# TANNER RANCH FILING NO. 1 SITE CONSTRUCTION DRAWINGS

EL PASO COUNTY, COLORADO

TYPICAL TEMPORARY GRAVEL RURAL LOCAL CROSS-SECTION  
N.T.S.

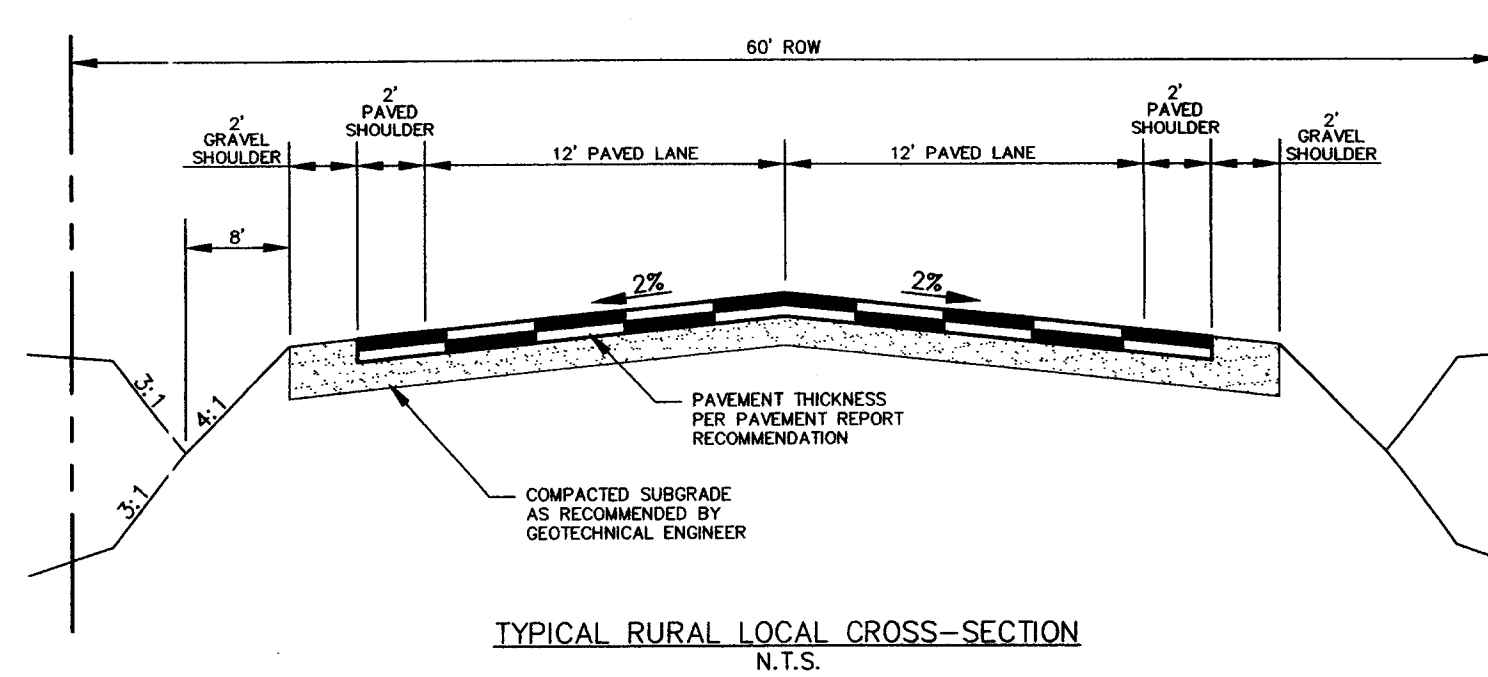
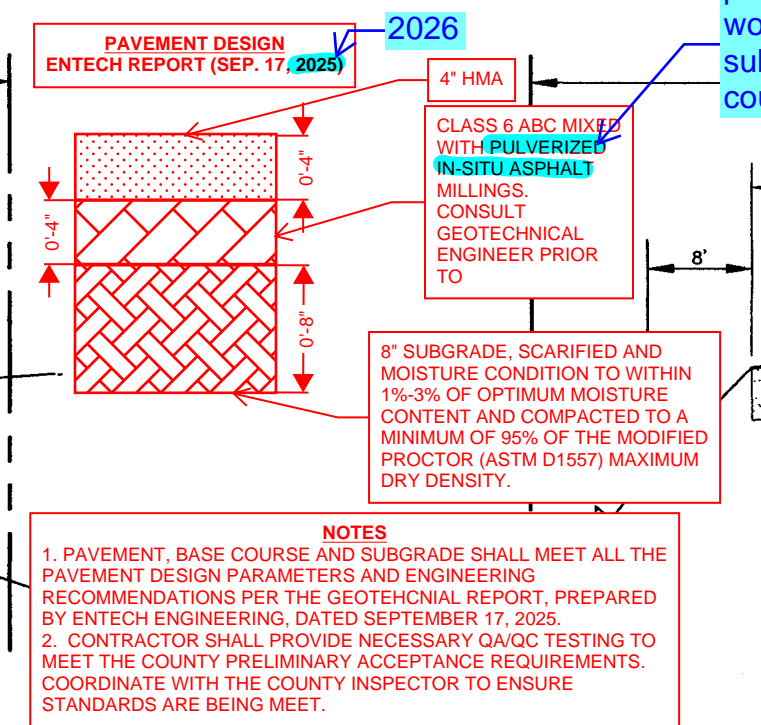
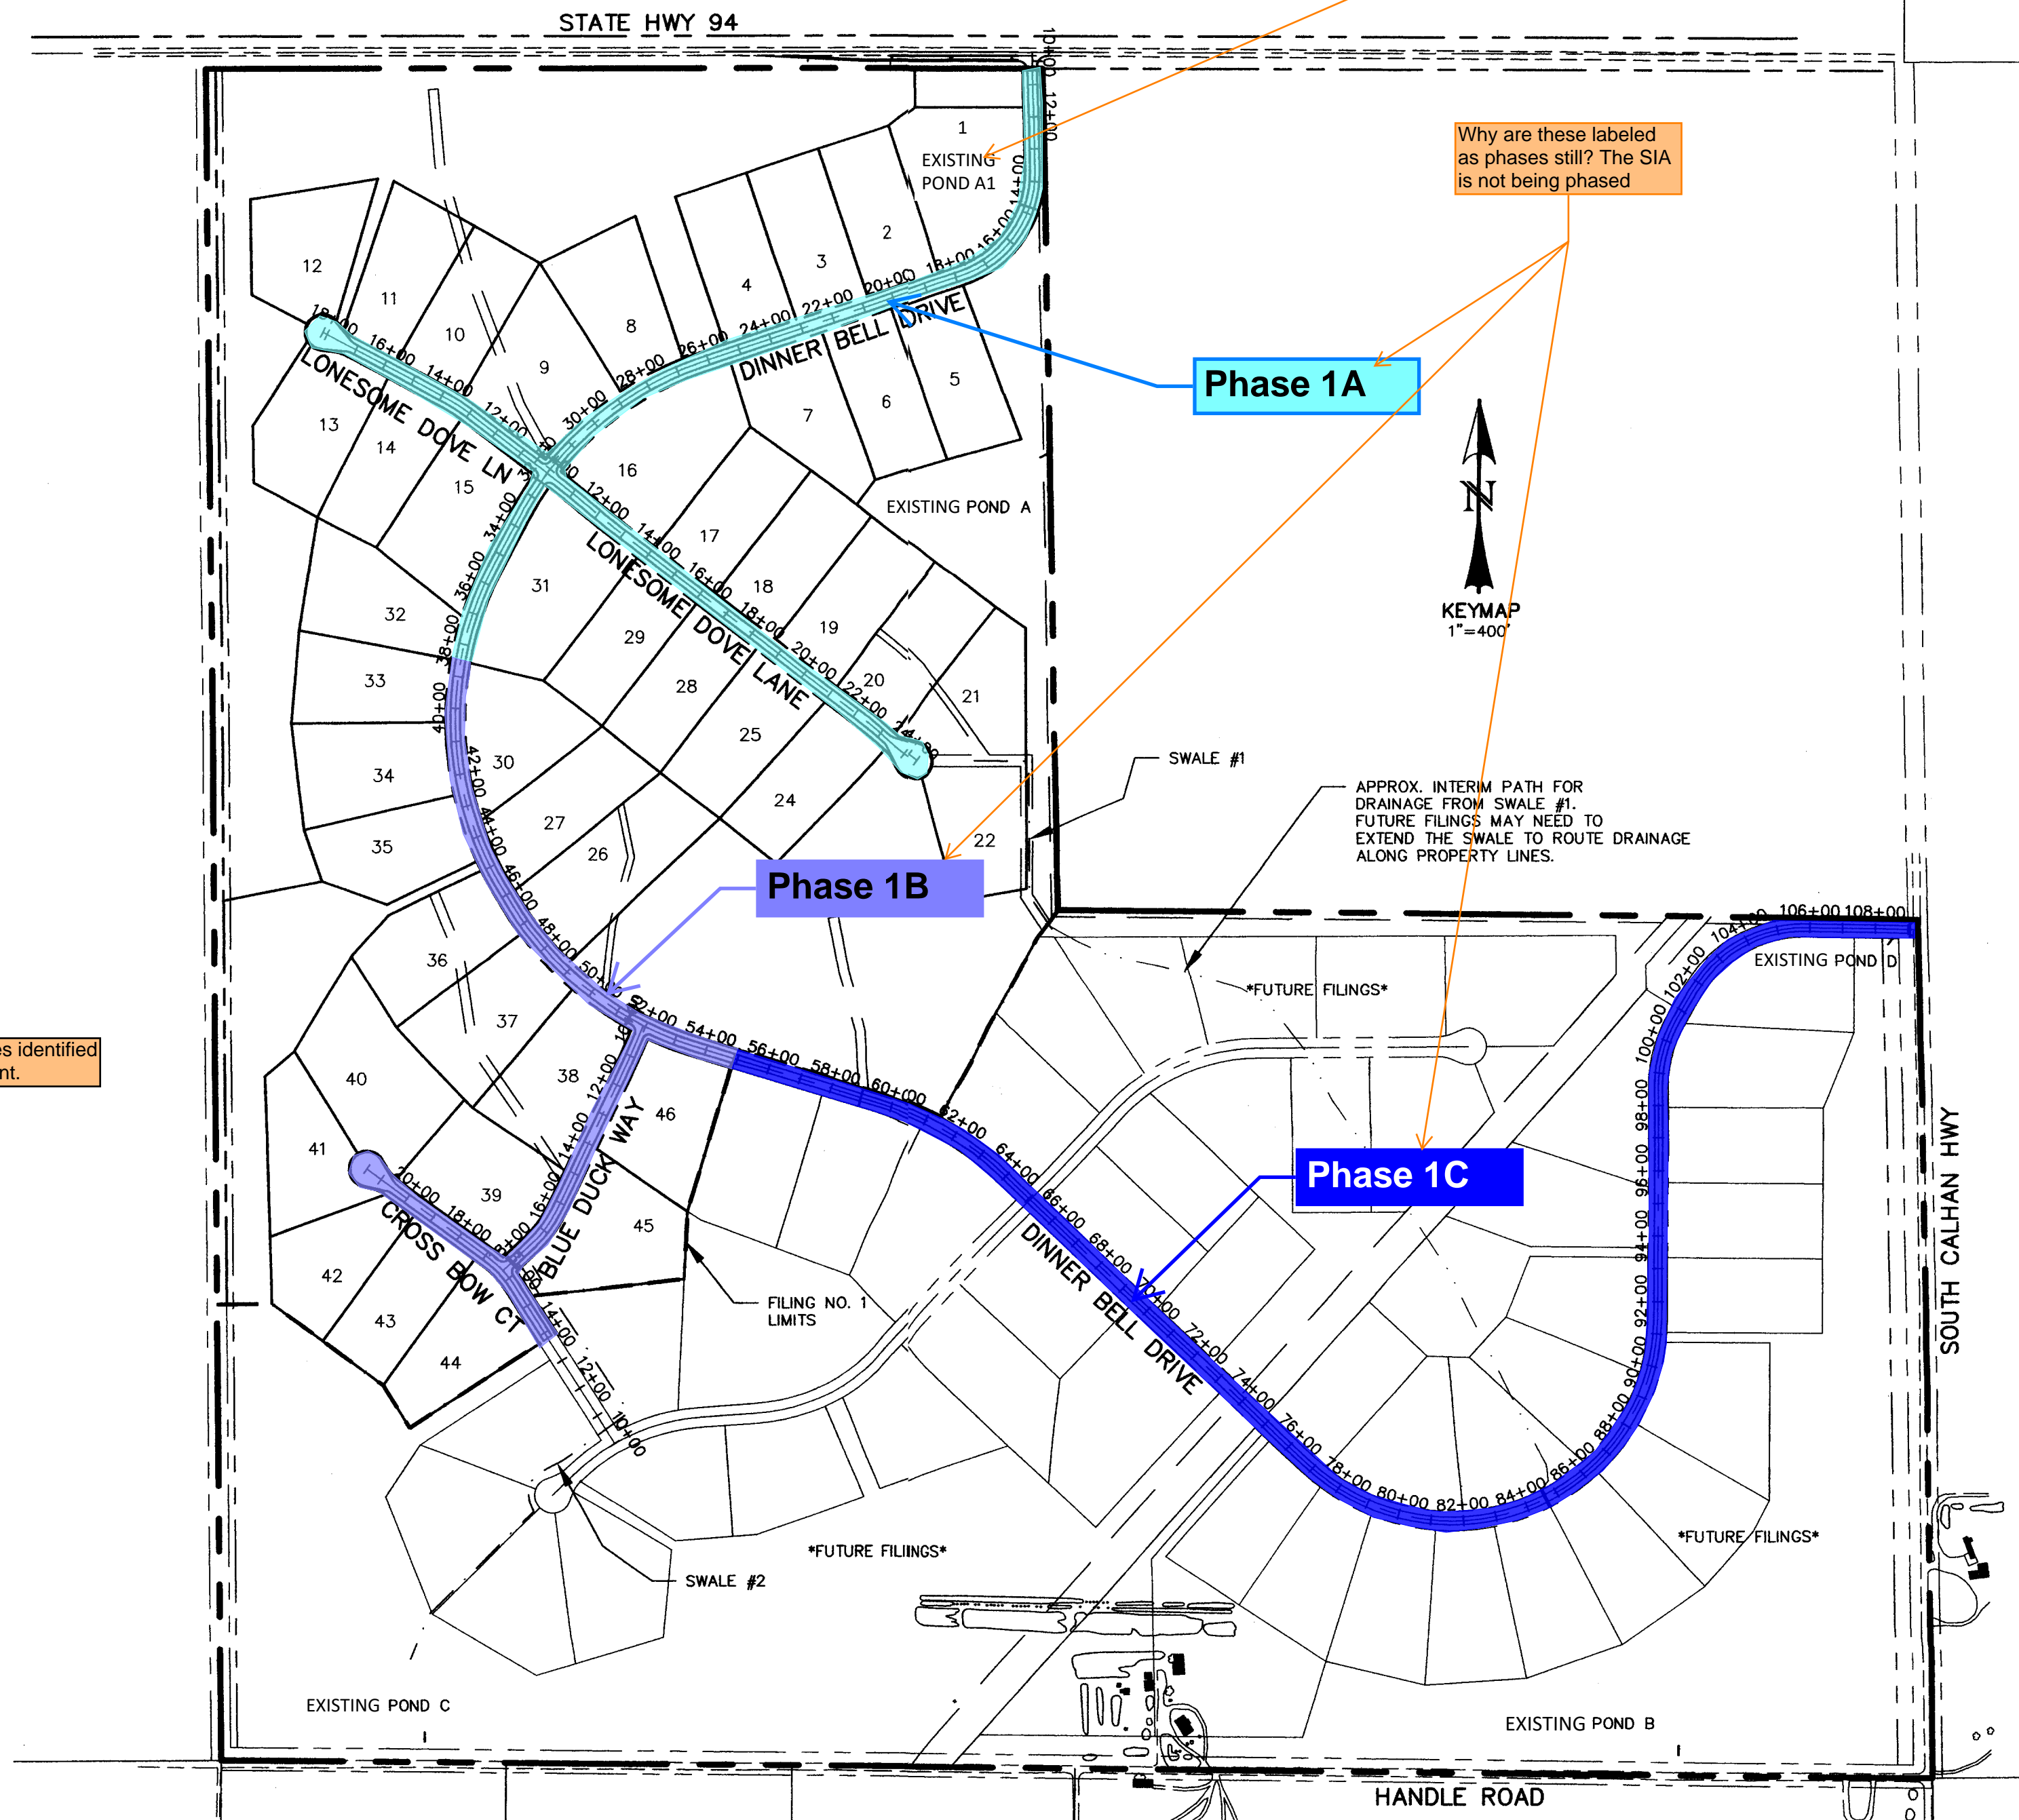
pulverized millings would be in the subgrade not the base course

POND A

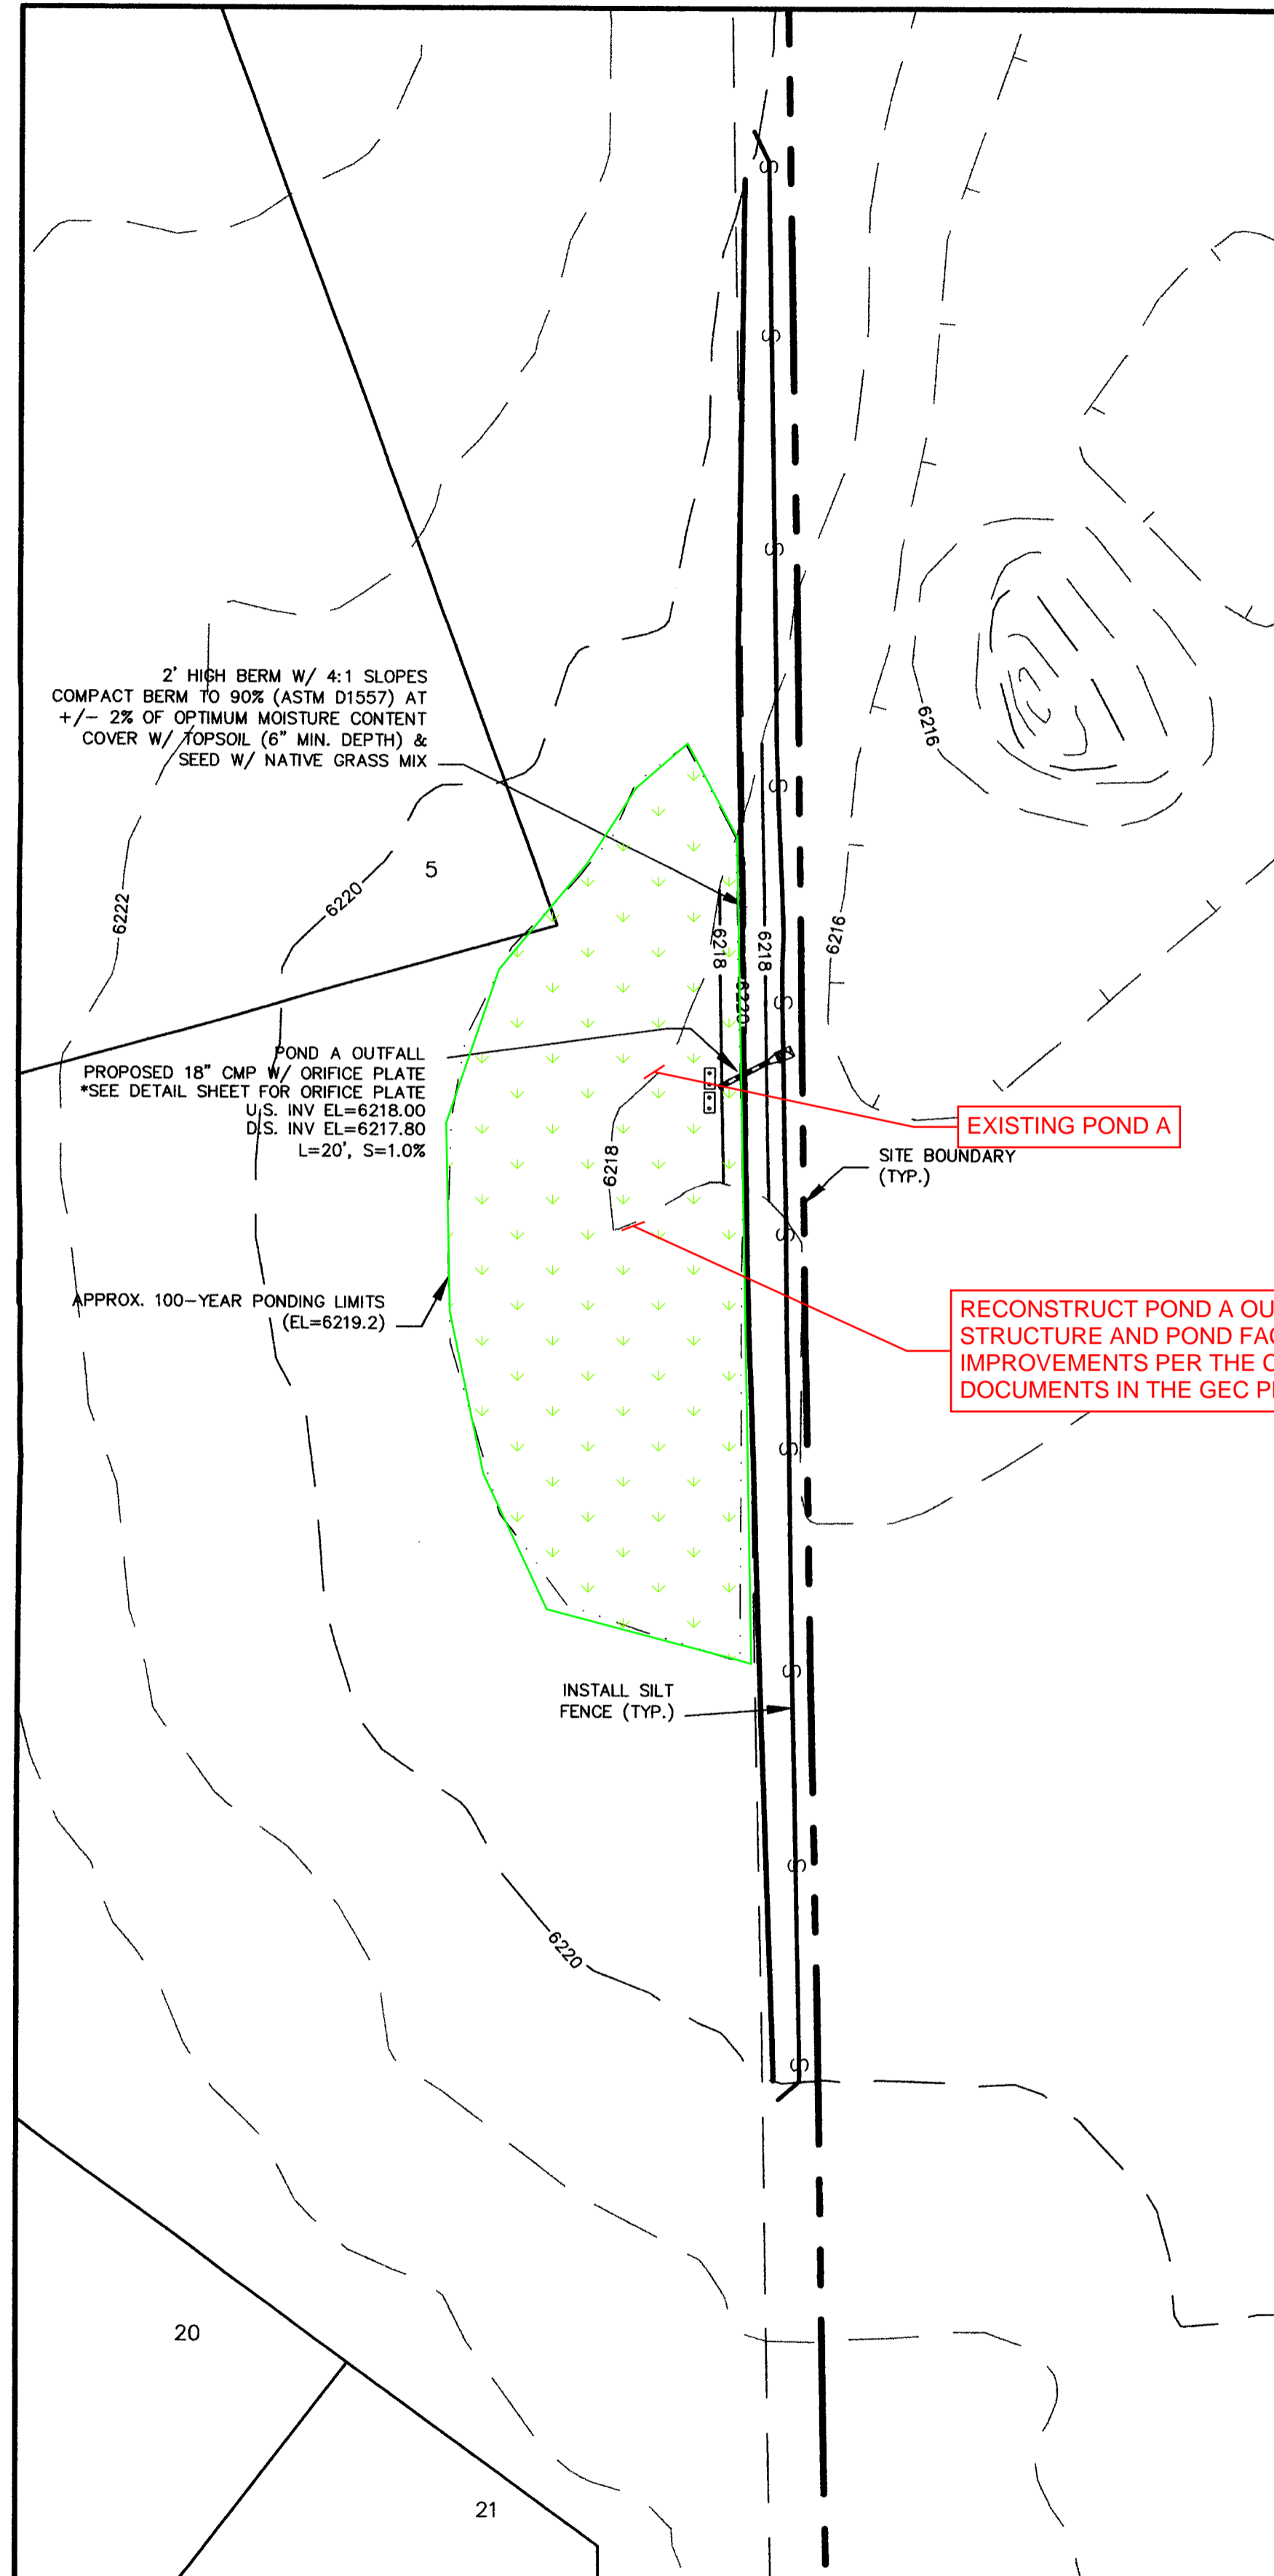
Pond A1 does not appear to be in these plans, does this need to be removed? Is Pond A needed?

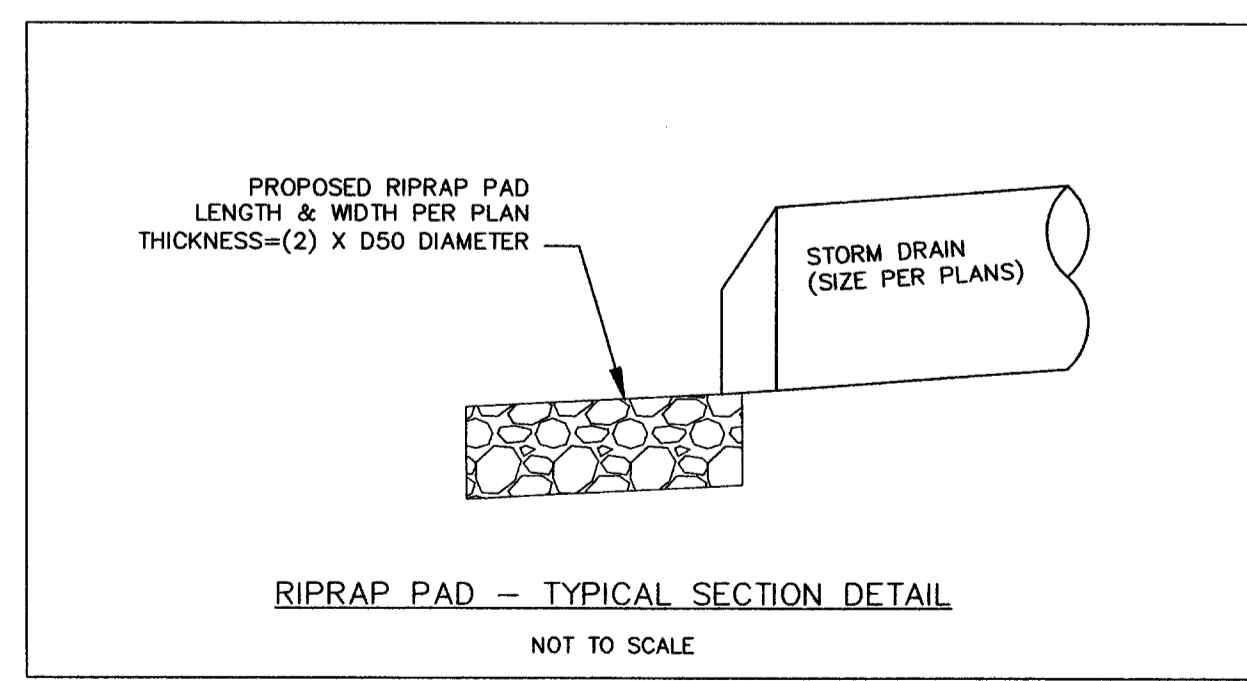
Provide discussion and calcs in the drainage report supporting the new dimensions and orifice holes. We need updated calcs demonstrating the new dimensions still work.

These existing pond modification sheets will require additional review once calcs are provided we can reference
